**Flood Control Project Maintenance  
Levee Inspections****LMA District Cover Sheet****Spring 2014 Levee Inspection Results****Sacramento Maintenance Yard Maintenance Area 0004**

**Spring 2014 Levee Inspection Results**

**Sacramento Maintenance Yard Maintenance Area 0004**

Waterway			Bank	Unit Miles
Unit No. 01 Sacramento River			Right	3.40
	Spring (March - May)	Summer (June - August)	(September - November) Fall	Winter (December - February)
Unit Maintenance Rating (Fall Only)				
Date of Inspection	03/13/2014 - 03/13/2014			
DWR Inspector	John Williamson			
Accompanied By	Dave Williams Sacramento Maintenance Yard

Photo 2 of 2 : johngw\_s\_20140317\_645.jpg

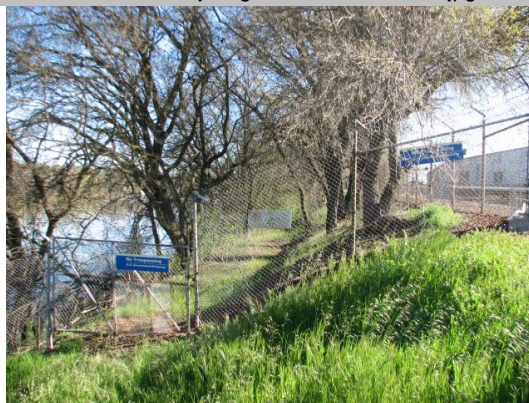
LM Start	0.28	Rating **	M	Issue No.	15 (cont)
LM End	0.44	Issue Type +	Ma	Location *	WS
Category	Earthen Levee			GPS Latitude/Longitude	
				Start	End
Item	Trim / Thin Trees			38.597188 °	38.598649 °
				-121.543401 °	-121.540960 °
DWR ID	DWR_MA0004_01_s _ 2012_15				
Action/Comments					
Trim and thin trees to allow visibility of the ground and room to flood fight.					
Inspector Comments: Chain link fence runs along the waterside shoulder of levee and no access to trim and thin trees or vegetation. This is the fence for the USACE Brythe Yard and runs the entire yard.

Trees on the waterside levee slope may obstruct visibility. Spring 2014

Photo 1 of 1 : johngw\_s\_20140317\_648.jpg

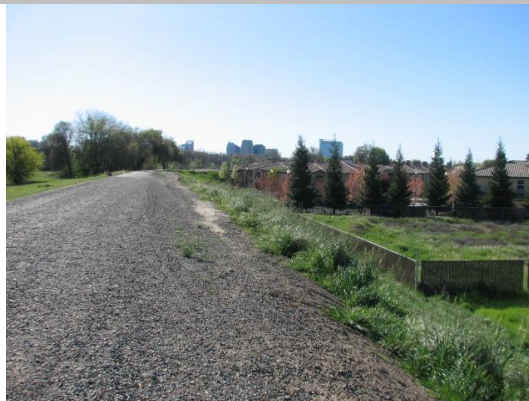
LM Start	1.97	Rating **	M	Issue No.	13
LM End	2.31	Issue Type +	Ma	Location *	LS
Category	Earthen Levee			GPS Latitude/Longitude	
				Start	End
Item	Vegetation			38.600092 °	38.595785 °
				-121.514142 °	-121.512753 °
DWR ID	DWR_MA0004_01_s _ 2014_13				
Action/Comments					
Control annual grass and weeds on the levee slopes and easements.

Tall grasses partially block visibility on the levee slope. Spring 2014
